SCHOOL IMPROVEMENT GRANT PROGRAMME 2 VISITS TO PACITAN & PANDEGLANG DISTRICTS

SCHOOL REHABILITATION CONSULTANT'S REPORT JUNE 2003

Plate 1: SDN Gendaran 01 showing inadequate column sizes, lack of intermediate columns to classroom wall and trusses over the centre of windows

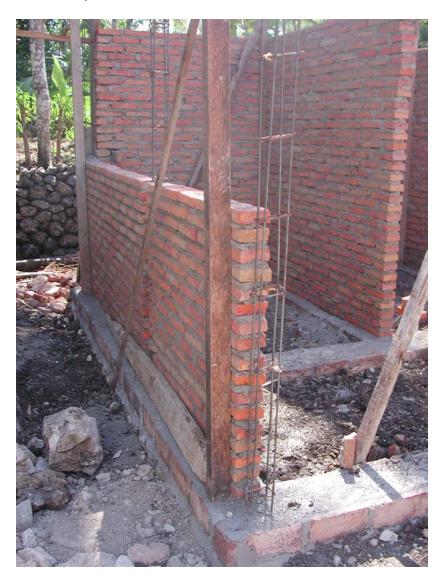
The new building is constructed of rendered brick walls, RC columns and beams, timber roof trusses, clay tiled roof, timber windows and panel doors. The trusses are good, made of good quality timber and the joinery and concrete are quite good but the structure of the new building is probably inadequate. The veranda columns are only 15 x 15cm and very high. The only visible RC columns in the classroom walls are at the cross walls and these are 15 x 20cm. If there are columns in between, they are only the thickness of the walls and they are not under the roof trusses; trusses are instead positioned over windows. The reinforcement to the columns to the toilets and the 'practical' columns to the classrooms is only 6.5mm with 3.5mm links at 25cm centres and is thus inadequate. There is some 8mm reinforcement on site and this was probably used for the main columns to the classrooms and verandas. This size is still however inadequate; it should have been 10mm or preferably 12mm. The consultants should check the structure as soon as possible and make proposals for strengthening it if necessary.

Plate 8: MTs Al-Fatah showing inadequate ground floor structure

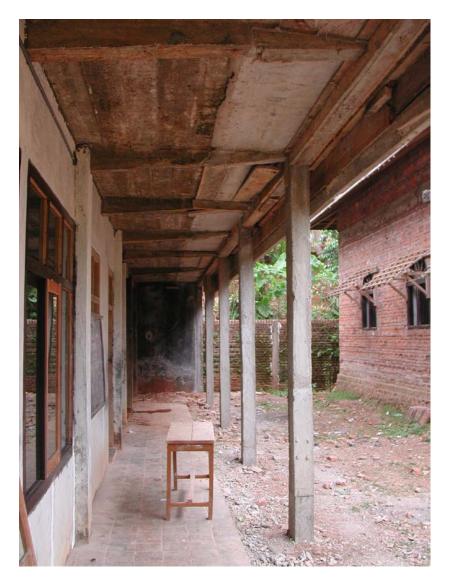
The original construction of the ground floor of this building leaves much to be desired. The columns and beams do not line up, the reinforcement to beams and columns all seems to be 8mm and there is very little cover to some of the reinforcement. The original cantilevered balcony at first floor level has been very badly extended in width by one metre and additional columns have been built (rather badly) on the outside to support it. There appear to be no columns in the classroom walls to the veranda (or if there are, they are only the thickness of the wall in width) and some of the cantilever beams occur over windows! The structural integrity of the ground floor must therefore be in doubt.

consultants should check the structure of this building as soon as possible to see if it is safe and if it is not, make proposals for strengthening it.

Plate 1: SDN Kadumerak showing new building with toilets at far end

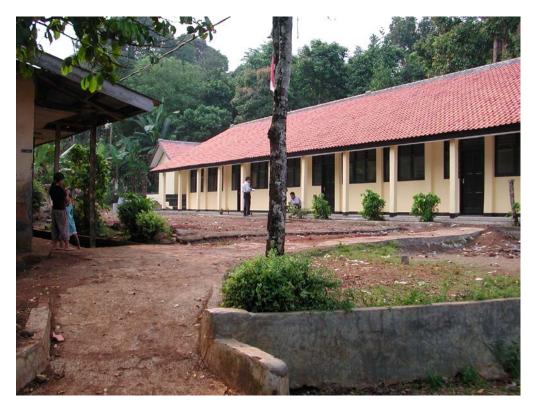
The new building is finished and is constructed of rendered brick walls, RC columns, RC veranda columns and beams, timber roof trusses, clay tiled roof, white glazed floor tiles to rooms and the veranda, timber windows and panel doors. The trusses could not be seen are good neither could the concrete work which is rendered. The roof seems quite well built and is reasonably straight and the windows and panel doors are well made. The rest of the construction is not very good however: the rendering is very rough and the painting, especially to the toilets is not very good. Some of the concrete columns are not very straight or plumb, the veranda columns are

Plate 7: SDN Kerangi 1 showing 6mm reinforcement to office building

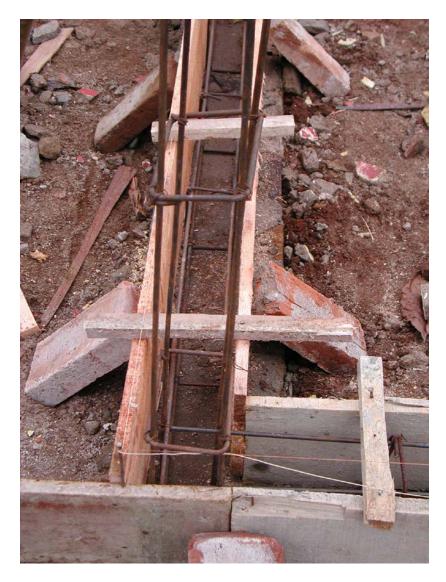
The SCA has visited five times but has not visited the site for three weeks and has not made much contribution. He prepared the budget and the drawings but made no technical comments on the work. The original proposal was to renovate only one classroom and one toilet. However the community have donated materials and labour in order to increase the amount of renovation work possible.

Plate 8: SDN Banjar Negara 1 showing very poor concrete

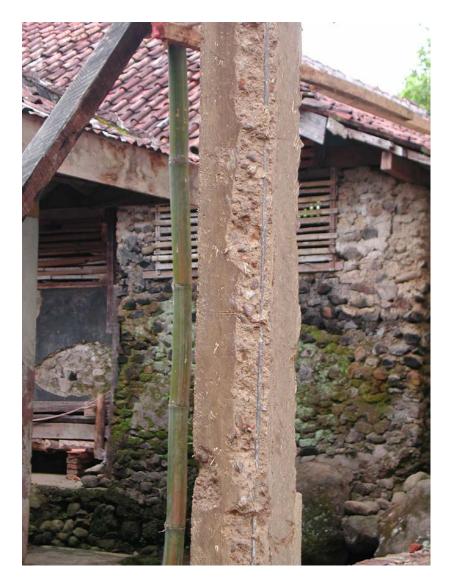
Some walls to the renovated building are being retained and there are new columns and beams to the veranda. The building has a new clay tiled roof, new roof trusses, new fibre-cement ceilings, new ceramic tiled floors and new timber windows and panel doors. The building is quite well constructed with good roof trusses and very good windows and doors. The veranda columns however are only 18 x 11 cms and have individual foundations and the concrete is very poor generally. The reinforcement to columns and beams is 8mm.
